Justification for Class II permissive change – AT&T1430

FCC ID: EW780-5125-H01 & EW780-5125-B01

The description Difference Between AT&T1430 and AT&T1430MK2

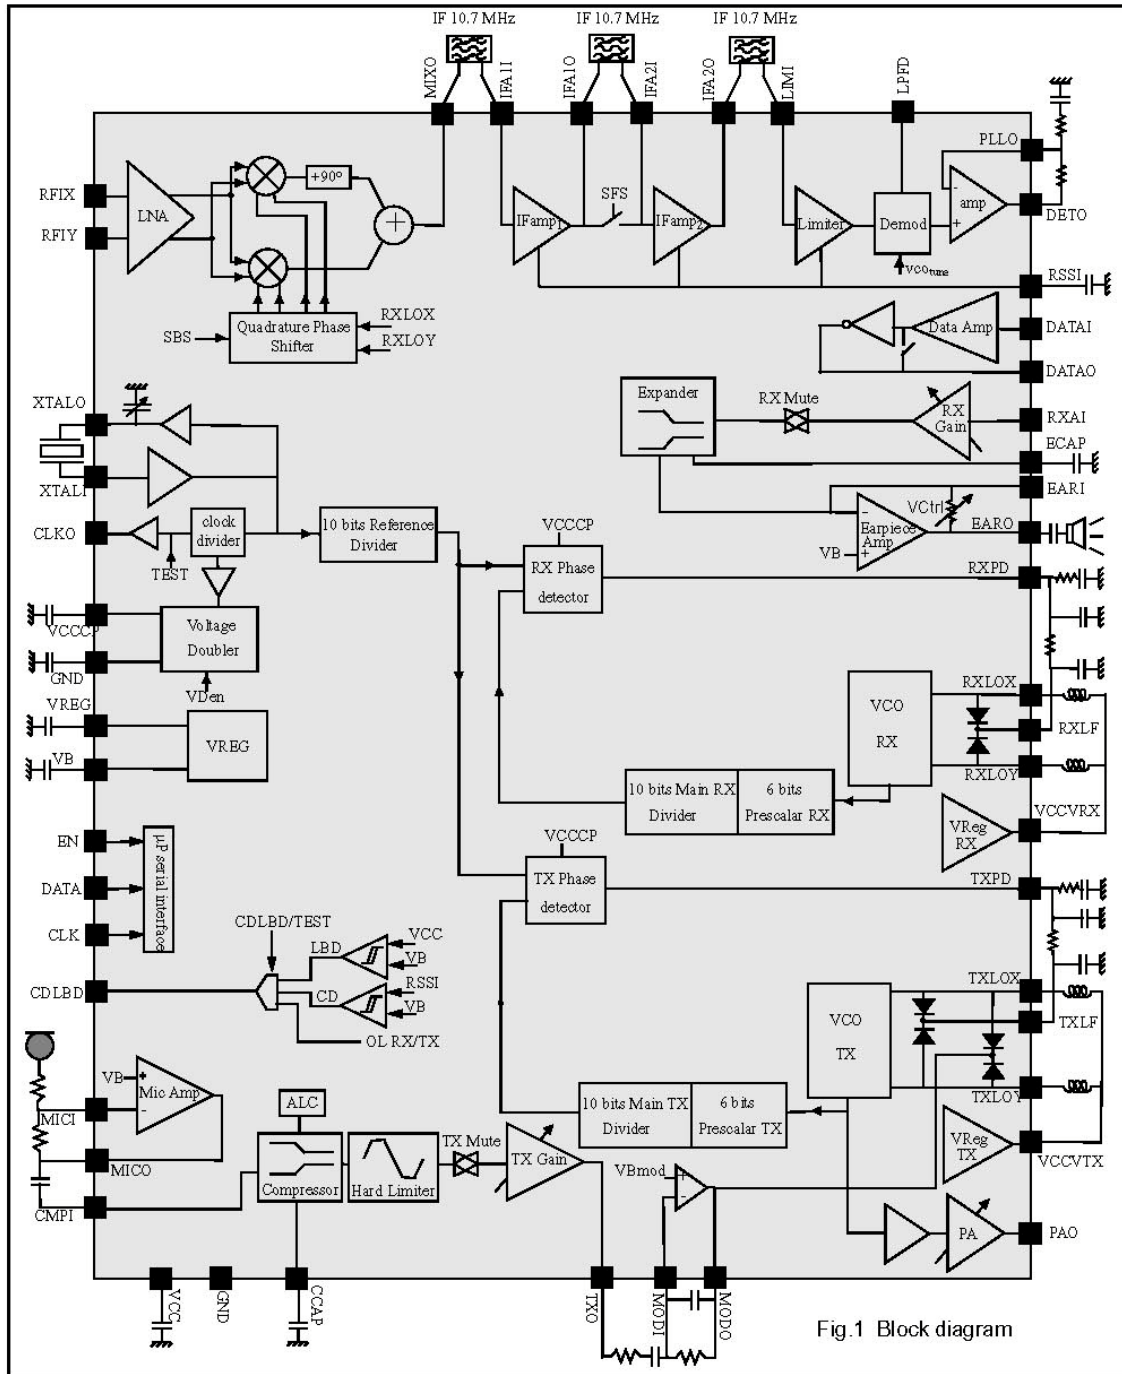
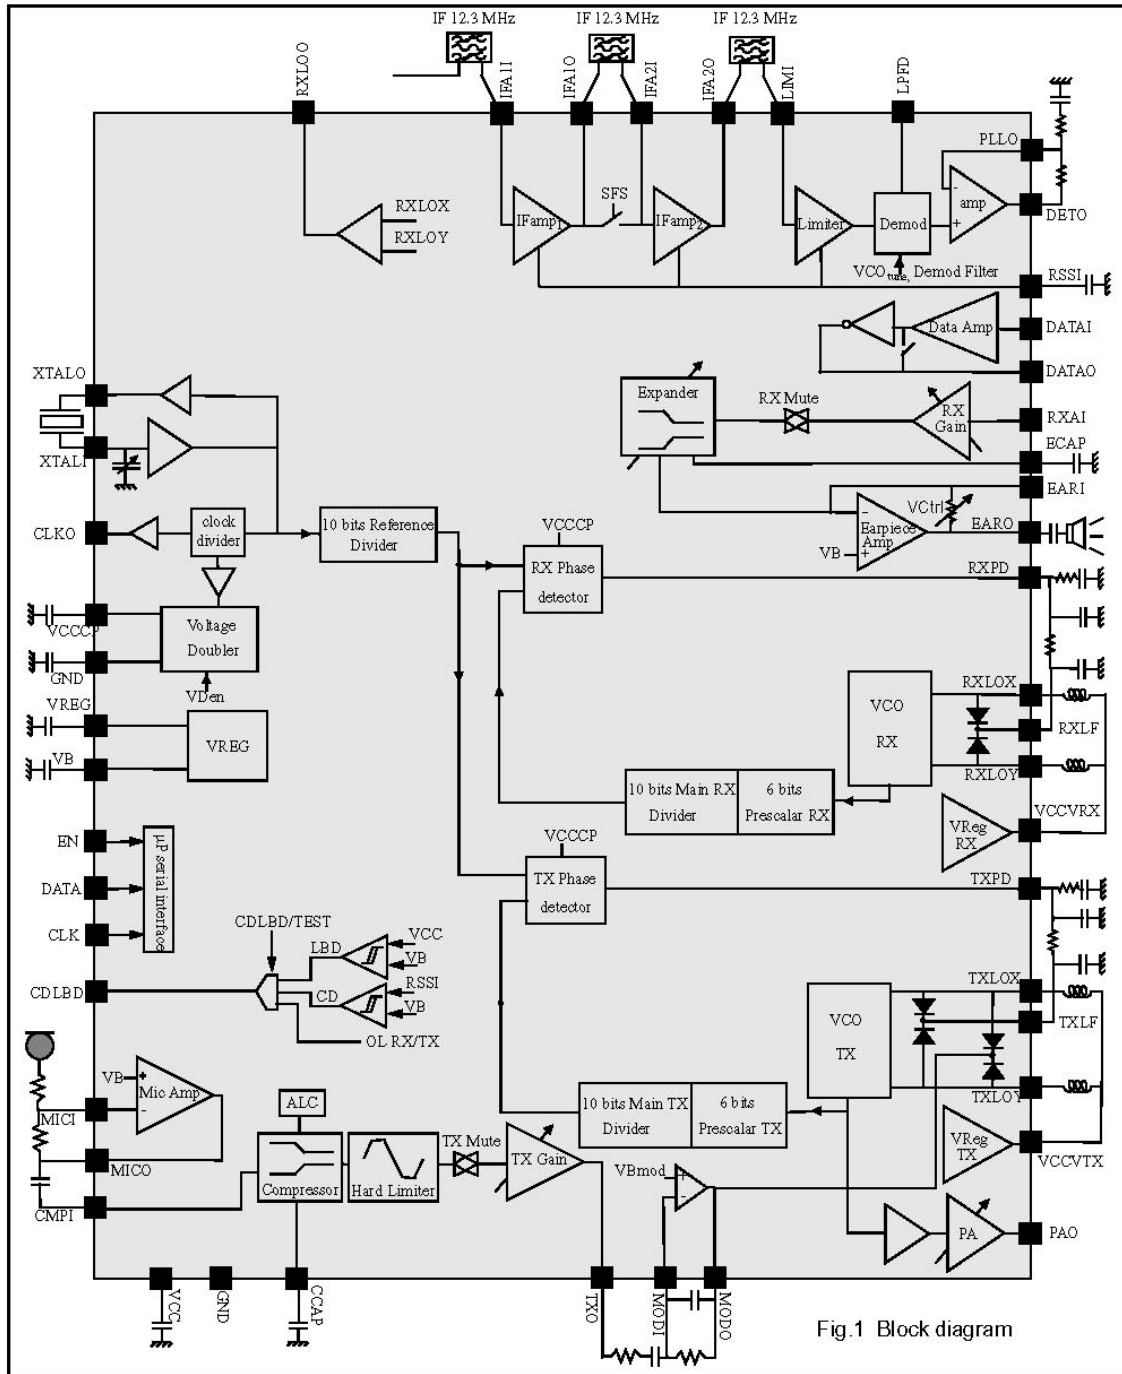
- a) Internal block diagrams of U3515 (old) & U3517B (new) – attached.
U3515 is a 900MHz RF IC, so in previous design the Rx PLL, VCO, LNA, Mixer could not be used on Handset receive (2.4GHz).
In the new U3517B, the Rx PLL, VCO are re-designed for 2.4GHz, so previous external discrete Rx PLL, VCO are no longer required. The unused LNA, Mixer insider U3515 were not implemented in the new RF IC U3517B as shown in the block diagram.
- b) The above was also mentioned in the Theory of Operation filed in FCC during previous new approval (10/1/01) on EW780-5125-H01 & EW780-5125-B01. The full doc. can be available for comparison when request.

- 1) Tx – using discrete components to replace LC filter is not considered as major change.
- 2) Rx – the integration of Rx PLL & VCO to RF IC U3517B is a planned migration that keeps all RF stages & frequencies remain the same. This will not affect the intended radiation & the unintended radiation was tested & verified to be within FCC limits.
